1997 - 1998 Corvette: Service Bulletin: Loose Lower Front Fascia Valance Panels

Number: 73-15-12A

SUBJECT: LOOSE LOWER FRONT FASCIA VALANCE PANELS (INSTALL ADDITIONAL ADDITIONAL WASHERS)

MODELS: 1997-98 CHEVROLET CORVETTE - BUILT PRIOR TO VIN BREAKPOINT W5127967

Figure 1

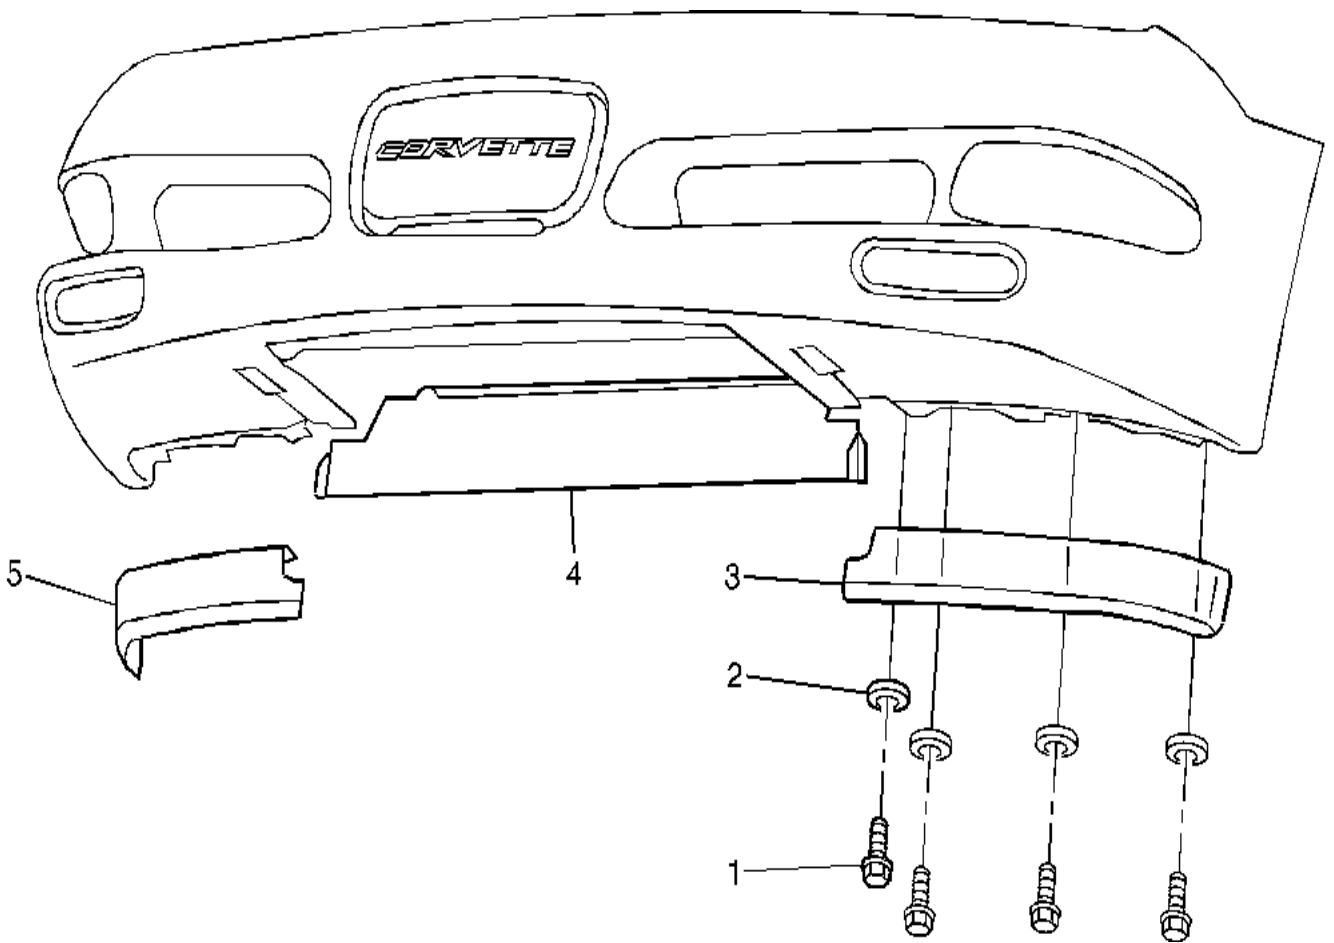
SOME OWNERS MAY COMMENT THAT THE LOWER FRONT FASCIA VALANCE PANELS APPEAR LOOSE.

THE ORIGINAL WASHERS ON THE BOLTS/SCREWS THAT ATTACH THE LOWER VALANCE PANELS TO THE FRONT FASCIA MAY HAVE WORKED THEIR WAY THROUGH THE HOLES IN THE VALANCE PANELS.

ADD ONE ADDITIONAL LARGER FLAT WASHER, P/N 11500365, 25 MM O.D. BY 6.3 MM I.D. BY 2.5 MM THICK (1 IN. O.D. BY 1/4 IN. I.D. BY 3/32 IN. THICK) TO EACH OF THE EIGHT BOLTS/SCREWS (FOUR PER VALANCE PANEL) THAT ATTACH BOTH LOWER VALANCE PANELS TO THE FRONT FASCIA (SEE FIGURE 1). TIGHTEN BOLTS TO 7 N.M (62 LB IN).

VEHICLES BUILT AFTER THE ABOVE LISTED VIN BREAKPOINTS HAVE VALANCE PANELS WITH A SMALLER HOLE DIAMETER AND NEW FASTENERS. AS A RESULT, IT IS NOT NECESSARY TO INSTALL ADDITIONAL WASHERS ON THESE VEHICLES.
